**WEISS MIXED USE DEVELOPMENT
SP09-26A WITH
ZONING MAP AMENDMENT 18.690**

Public Hearing at the request of Siegal Tuomaala Associates, for Planning Commission's recommendation to City Council for rezoning of property in Section 26, east of Ten Mile Road, and south of Novi Road, from I-1, Light Industrial District and OS-1, Office Service District to B-2, Community Business District and OS-1, Office Service District with a Planned Rezoning Overlay (PRO). The subject property is approximately 28.7 acres.

Rezoning with Planned Rezoning Overlay – REVISED SUBMITTAL
SP# 09-26A/Rezoning 18.690

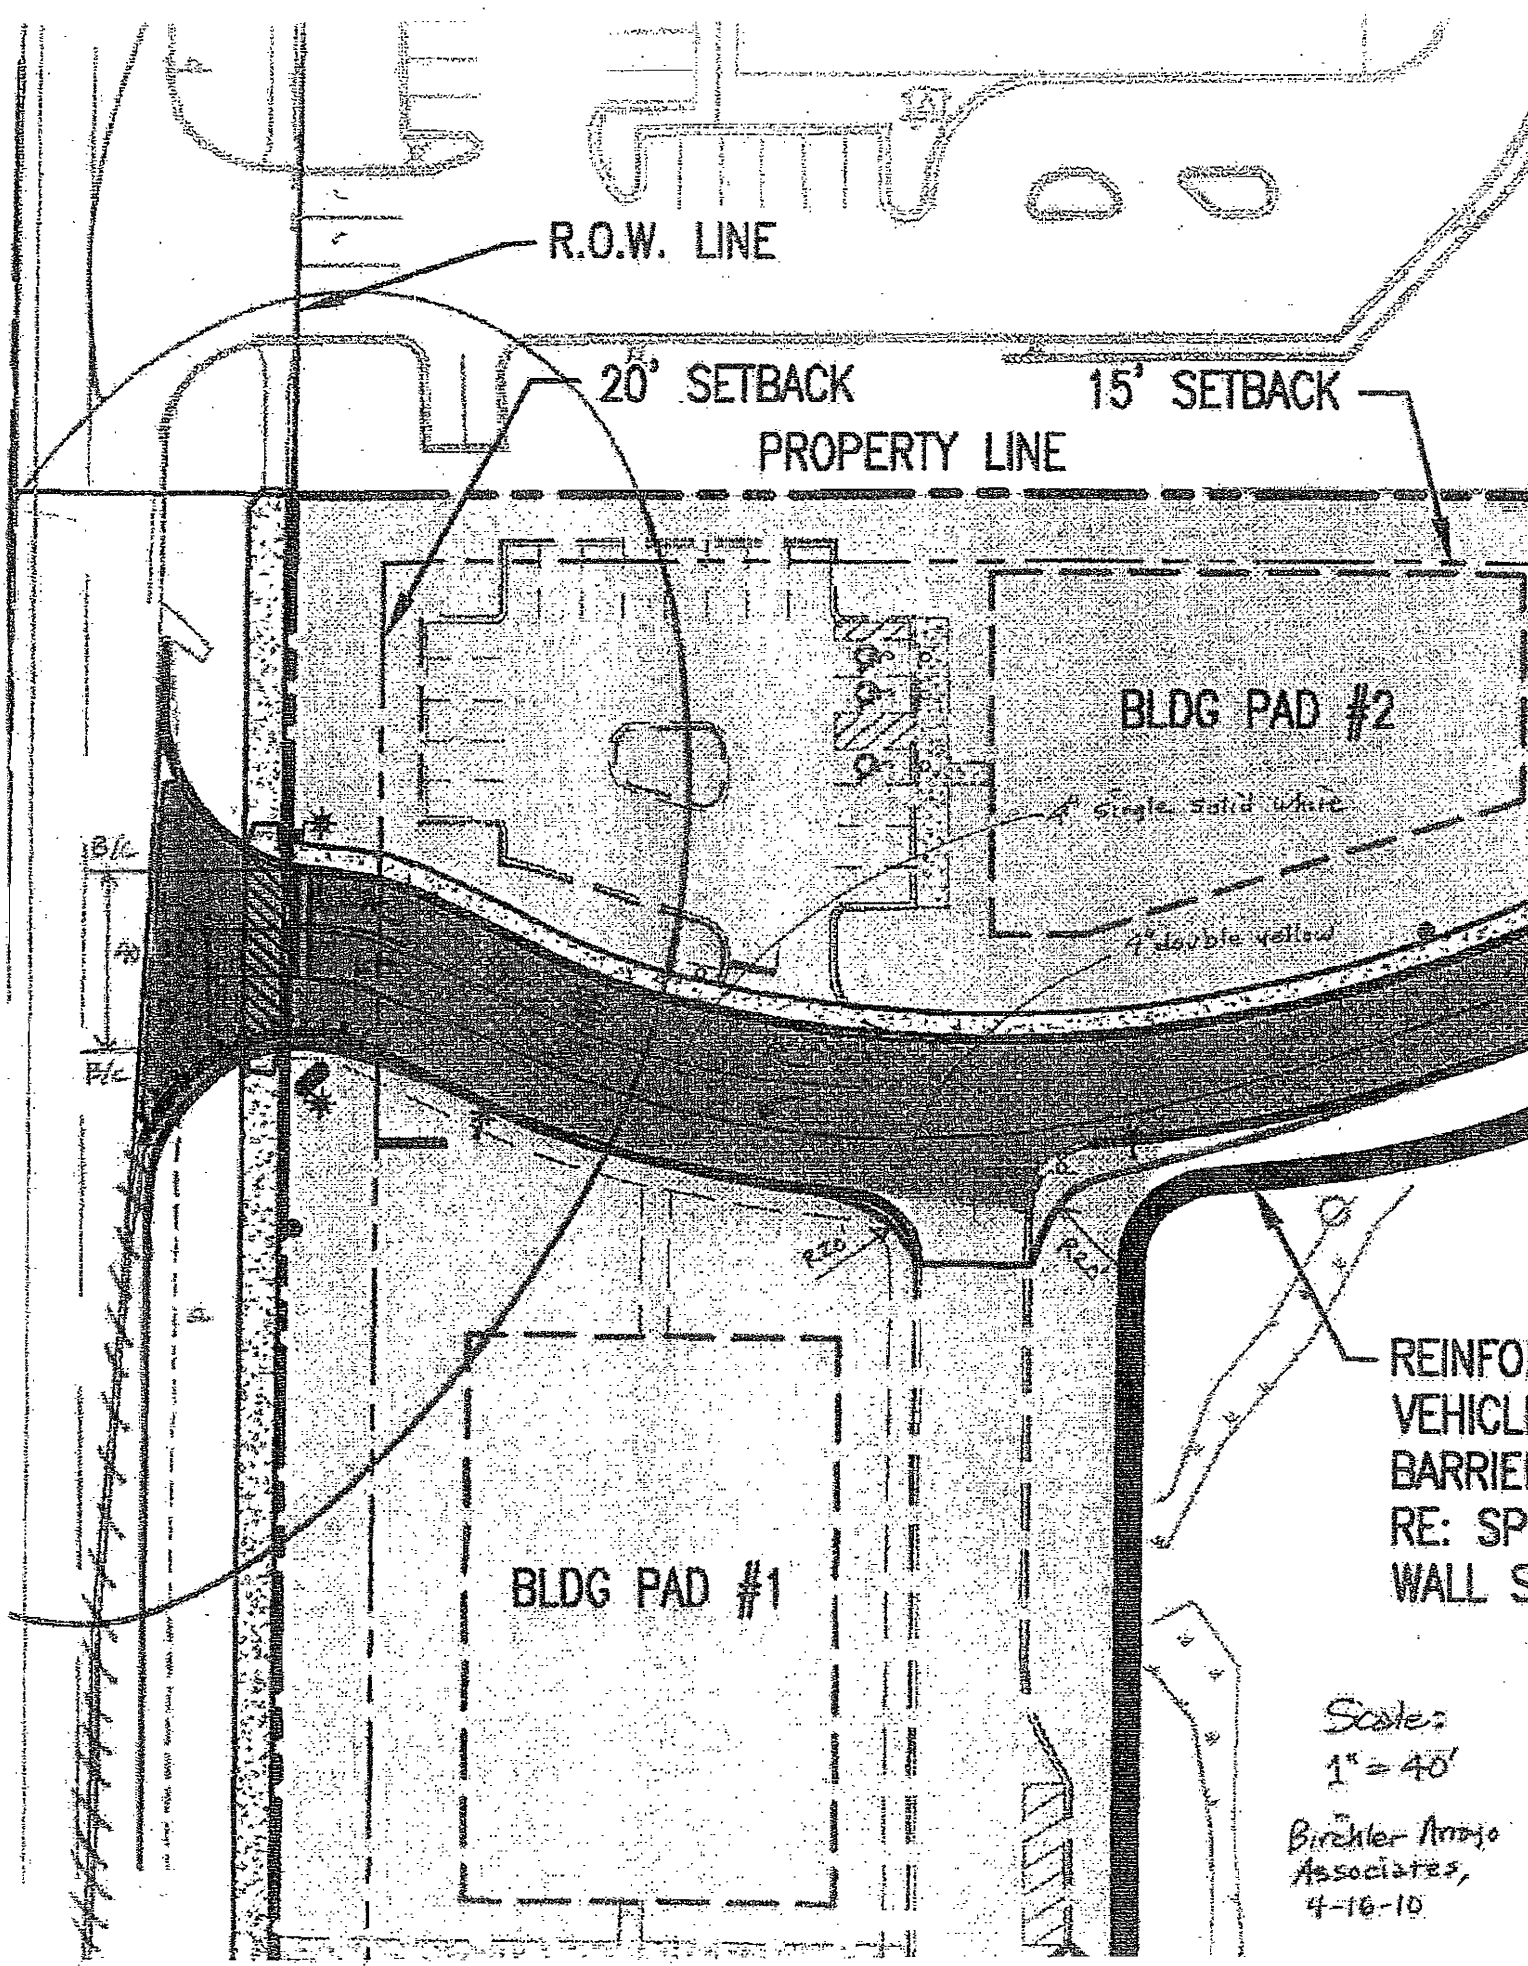
12. While the proposed Novi Road access drive has been widened to three lanes a short distance into the site, there is no transition for eastbound (entering) traffic to shift over east of the outlot. Our recommended conceptual design, attached, provides 125 ft of two-lane stacking for exiting traffic as well as an appropriately curved transition to one eastbound lane. It appears that our design would not require any modifications to the retaining wall / guardrail on the south side of the drive.
